Prairie Island Nuclear Generating Plant Units 1 and 2
Dockets 50-282 and 50-306
License Nos. DPR-42 and DPR-60

Responses to NRC Requests for Additional Information Dated November 25, 2008
Regarding Application for Renewed Operating Licenses

Enclosure 1
NSPM Responses to NRC Requests for Additional Information
Dated November 25, 2008

Sketch of Spent Fuel Rack Fuel Module Assembly

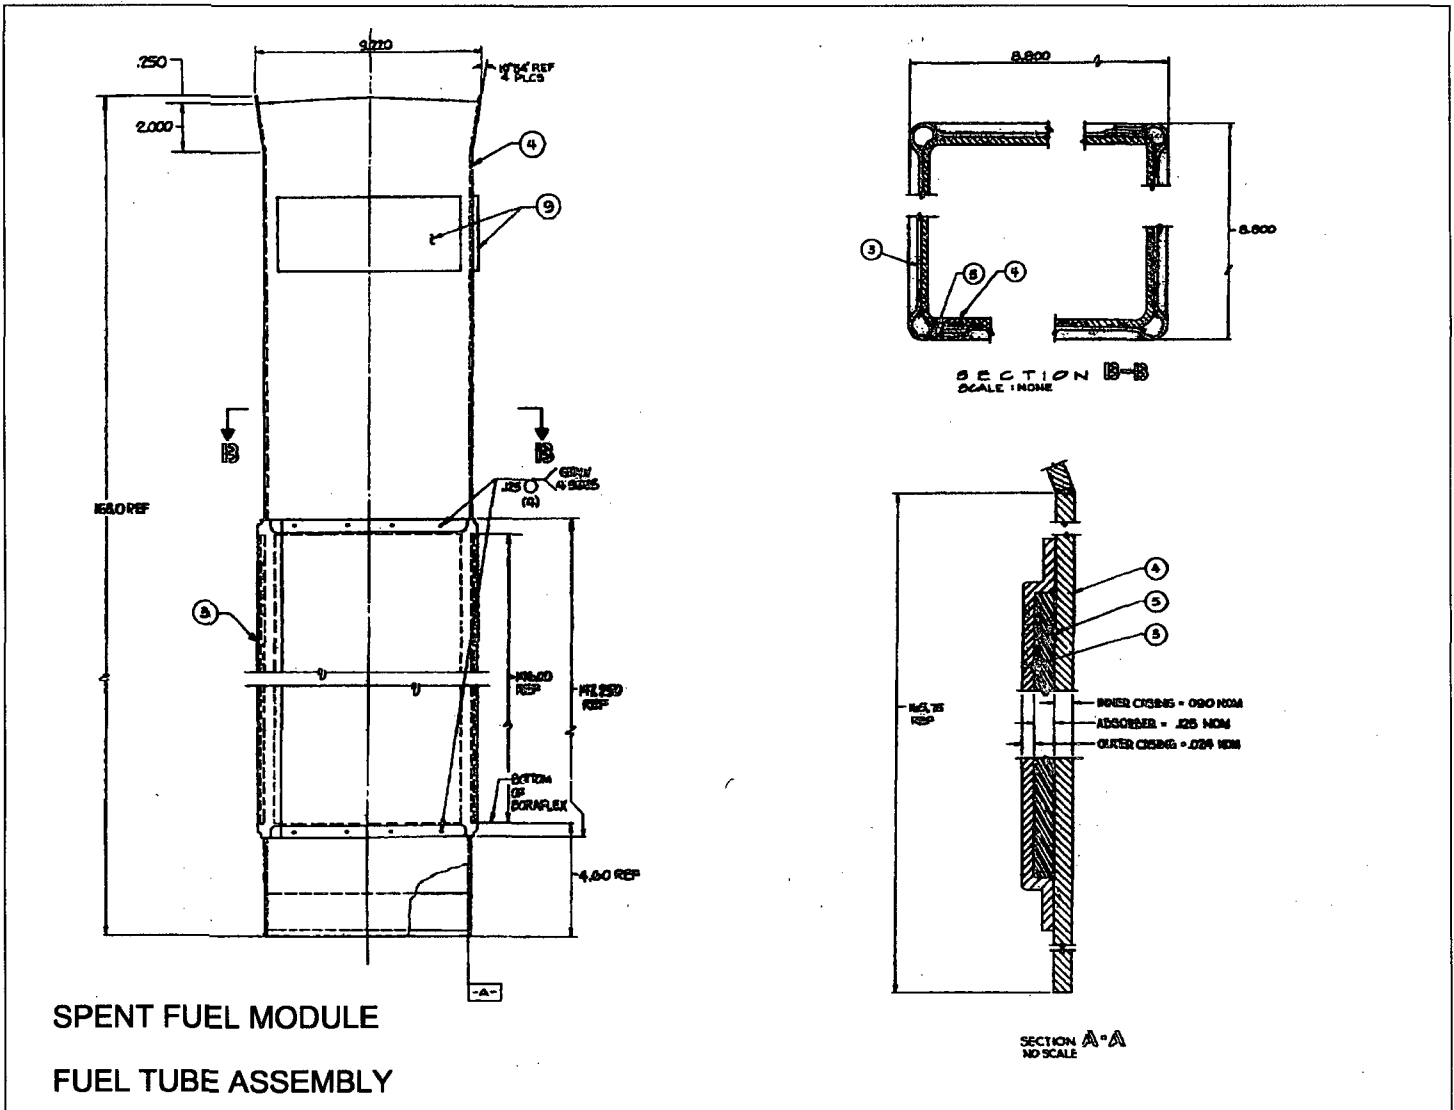
Prairie Island Nuclear Generating Plant (PINGP) Units 1 and 2 have Boraflex that is no longer credited for criticality in the spent fuel pools. There is no indication whether or not they still monitor the Boraflex for degradation. Past operating experience indicates that there can be blistering and bulging of the Boraflex material and the cladding surrounding the material. This can cause potential fuel handling safety issues.

Although Boraflex is not credited for criticality in the PINGP Unit 1 and 2 spent fuel pools, degradation of the material may impede safe handling of the spent fuel if blistering and/or bulging of the rack occurs. How will potential degradation of Boraflex material be identified and monitored during the proposed period of extended operation? If degradation of Boraflex is identified, what mitigation strategies will be employed?

The spent fuel storage racks are described in the PINGP USAR, Section 10.2.1. Criticality is prevented by the design of the racks which limits fuel assembly interaction by fixing the minimum separation between assemblies, and by maintaining soluble neutron poison in the spent fuel pool water. No mitigative strategy is required for monitoring the spent fuel pool Boraflex material used in the design of spent fuel storage rack fuel module assemblies. The design of the PINGP spent fuel storage rack fuel module assemblies allows for the release of gasses created by the degrading Boraflex material without degrading the surrounding stainless steel material.

The spent fuel storage rack fuel module assembly design at PINGP incorporates Boraflex which differs from the design that incorporates Boral™. Boraflex is a material composed of 46% silica, 4% polydimethyl, and 50% boron carbide. The fuel module assemblies consist of an inner stainless steel casing, a layer of Boraflex neutron absorbing material, and an outer stainless steel casing (see sketch below). The inner and outer square stainless steel casings are tubular. The outer casing holds the Boraflex in place and is only one-quarter the thickness of the inner casing. The outer casing is attached to the inner casing by four spot welds at the top and bottom of the outer casing on each of the four sides. Thus, the outer casing is not leak tight. This vented cavity design allows the release of gasses and ingress of water to alleviate the potential for cell wall bulging as a result of the Boraflex material off gassing.

Industry OE indicates that Boraflex degrades over time, but the degradation process does not impede the ability to remove or accept fuel since the fuel module assembly's open flow design allows gasses to vent safely to the spent fuel pool water. Bulging, blistering, or other deformation, known to occur in poorly vented designs, is not applicable at PINGP.
